SUBJECT: R.E. Ginna Nuclear Power Plant
Docket No. 50-244

Reply to Request for Additional Information Associated with the Proposed License Amendment Request Regarding Revision of Technical Specification Limiting Conditions of Operation 3.3.2, 3.3.4, and 3.8.1

Response to Request for Additional Information Regarding Diesel Surveillance License Amendment Request

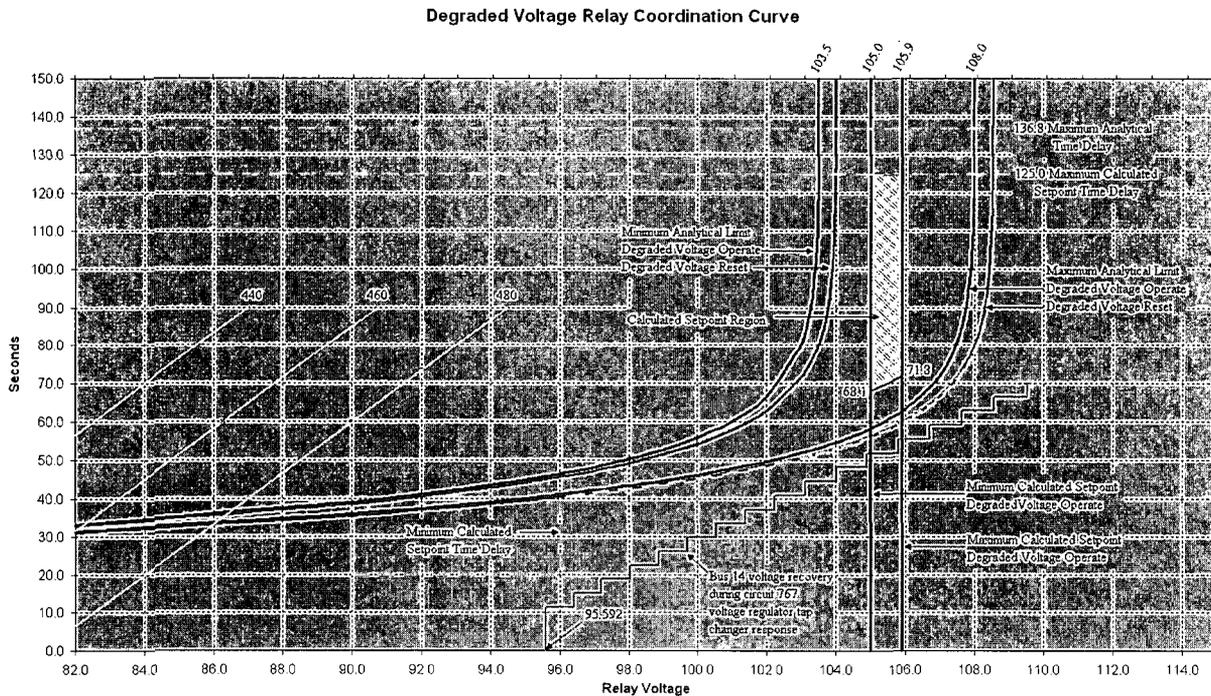
Provide a copy of the thermal capability curves of 440, 460, and 480 V motors which are discussed in Section 5.5 and shown on Page 45 of design analysis DA-EE-93-006-08, Revision 5.

Section 5.5 clarifies that Ginna does not have vendor supplied thermal capability curves for the 440, 460 and 480 V motors. Guidance contained in ANSI standard C50.41-2000 (American National Standard for Polyphase Induction Motors for Power Generating Stations) was utilized to approximate the thermal damage curves for incorporation in the relay coordination curve. This is also discussed in section 10.3.2 of the analysis.

The specific section of the ANSI criteria which was applied was section 13.3 on momentary operation of motors which states "motors shall be capable of operating at rated load for a minimum of 60 seconds when 75 percent of rated voltage at rated frequency is applied to the motor terminals". Utilizing this guidance, the 440 volt motor thermal damage curve would have an intersecting point at 60 seconds and 82.5 volts $[(0.75)(440)/(480/120) = 82.5 \text{ volts}]$. The intersecting points for 460 and 480 volt motors at 60 seconds would be 86.25 volts and 90 volts respectively using a similar calculation.

As stated in section 5.5, an actual thermal damage curve would follow an exponential function; however they are shown as straight lines on the coordination curve contained in the analysis for the reader to visualize the thermal damage curve for voltages above approximately 92 volts where the loss-of-voltage relay would actuate. This is considered a conservative approximation due to manufacturer designed-in margin which would permit longer operation at degraded voltage prior to failure occurring.

While performing a check of the analysis in responding to this question it was noted that the thermal damage curves were incorrectly plotted on the coordination curve contained in DA-EE-96-006-08. Corrective actions have been initiated at Ginna. The corrected coordination curve is below:
